TECHNICAL BULLETIN

Doc Nr: PDD2022_13 ed2
Date: 02/02/2023
Issued by: TTS - Product Support

Subject	<u>NEW Software TOUCH 5.5.0 & 5.5.2</u>
Model / PNC / Type reference	All ovens Gas & Electric (Touch screen version): • Electrolux Skyline Premium S (Level T), Pro S (Level K) • Zanussi Magistar Combi TS (Level T), Combi TI (Level K) • Diamond (Level T, K) • To Brand (Level T, K) • P codes (prototype ovens) • S codes (special execution ovens) • 190xxx codes
Symptom of fault	
Root cause	
Solution	
Action in Factory	New software in production
Date or s/n of introduction	5.5.0 from Wk. 50-2022 ser 2502000001 5.5.2 from WK 05-2023 ser 3052000001
Action in Field	New software is interchangeable towards all touch ovens in the market; It is recommendable to update the software and related parameters whenever visiting a site. mandatory to update the parameters file too
Spare parts

SOFTWARE UPDATE NOTES 5.5.0

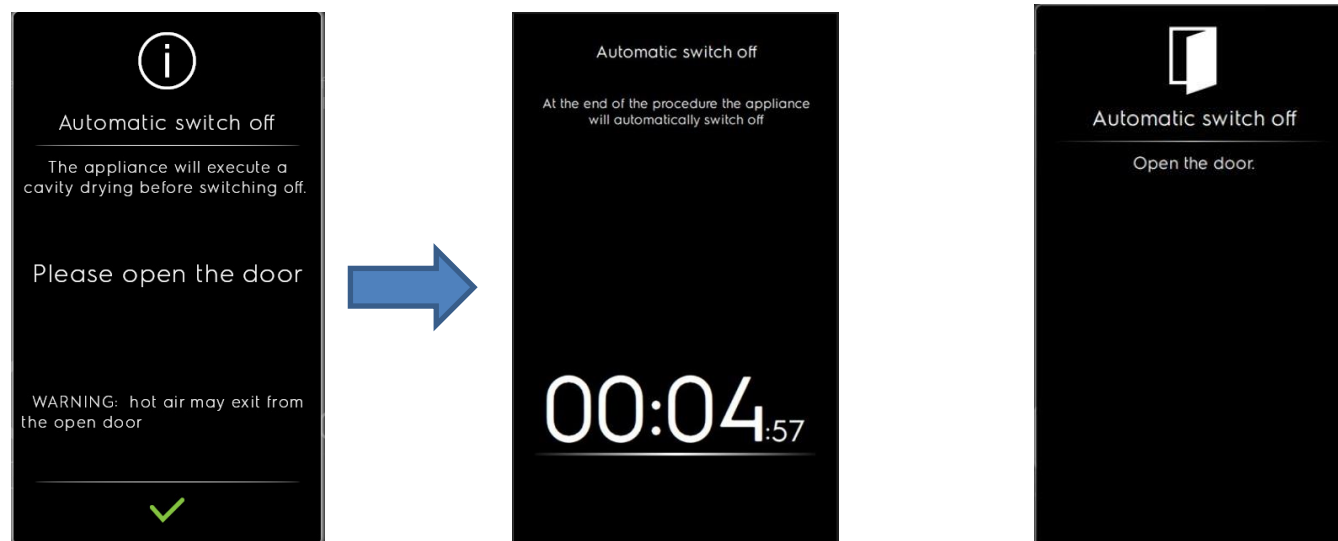
Automatic drying cycle, that will automatically start when the oven is turned off (pressing button 1/0).

When this parameter is enabled when turning off the appliance an automatic cell drying cycle will be performed.

Once that the green tick has been selected and the door has been opened, on the display will appear a timer of 5 minutes in countdown mode. If the door is not opened or is closed after start of the drying cycle a pop up “open the door” will appear but without a timer, in this case the cycle will last 30min (with door closed and flap open). Oven will turn off at the end of the cycle.

UI "Two touch" mode

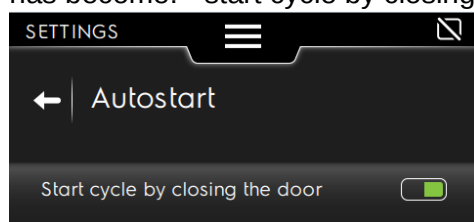
This operative mode forces the user to touch at least twice the display in different positions to execute a program. The goal of "two touch" mode interface is to satisfy regulatory requirements for gas appliances and update the "start by closing door" mode.

With this feature enabled the oven starts the cooking cycle when the door is closed and the end condition (timer value or food core temperature) of the first phase. Initially the display shows "----" avoiding the oven to start the cycle when the door is closed. This allows the user to change or update the settings of the phase, adding more phases before starting the cycle.

To start the cycle the user presses "----" the input popup is shown with the default value for the end condition. Confirming the popup, the value is set and the cycle starts.

- 1.Settings→Autostart→Switch on "Start cycle by closing door"
- 2.Parameter 459 "2tch" must be enabled, by default is set 0, "Disabled"

Clearer messages for recovery modes

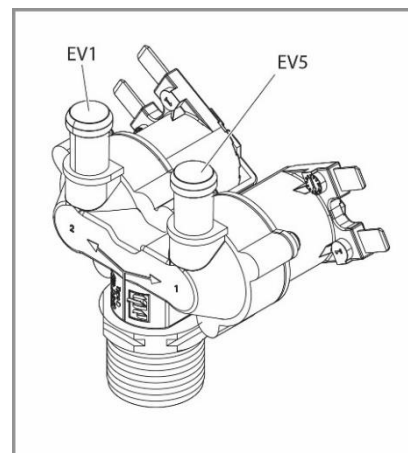
When a recovery mode popup appears, it displays specific messages to give the user hints on what is the effect of its activation. The messages have been improved to facilitate the understanding.

Review of alarm descriptions

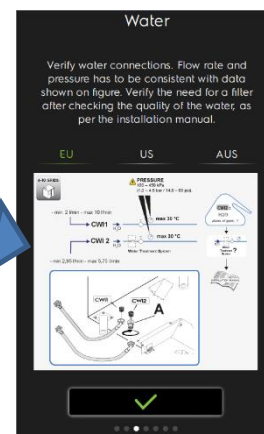
Alarm descriptions of the display popups have been reviewed and updated; they have been improved to facilitate the understanding.

Lambda recovery mode

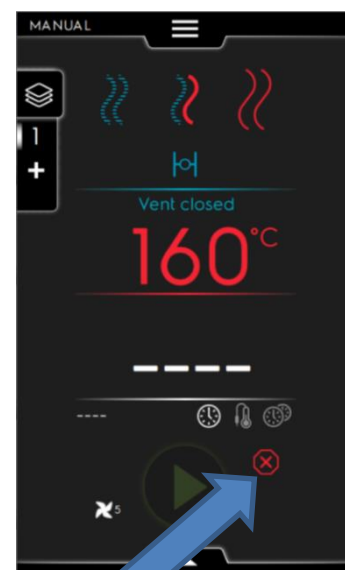
The parameter 456 LSEn (set default as **normal** ; 0, "Normal" / 1, "Advanced" / 2, "Hidden") determines the mode used to alert the user that the lambda probe is broken can be:

-“**normal**” mode, the ongoing cycle is blocked and the alarm is notified with a pop up in the standard way.

-“**advanced**” and “**hidden**” mode, the ongoing cycle is not blocked and the recovery mode is activated instantly. Furthermore, no alarm popup is displayed.

In the “**advanced**” mode the *ALARM ICON* is displayed and clicking on it the user can view the alarm popup.

In “**hidden**” mode the alarm is not notified to the user in any way during the cycle.
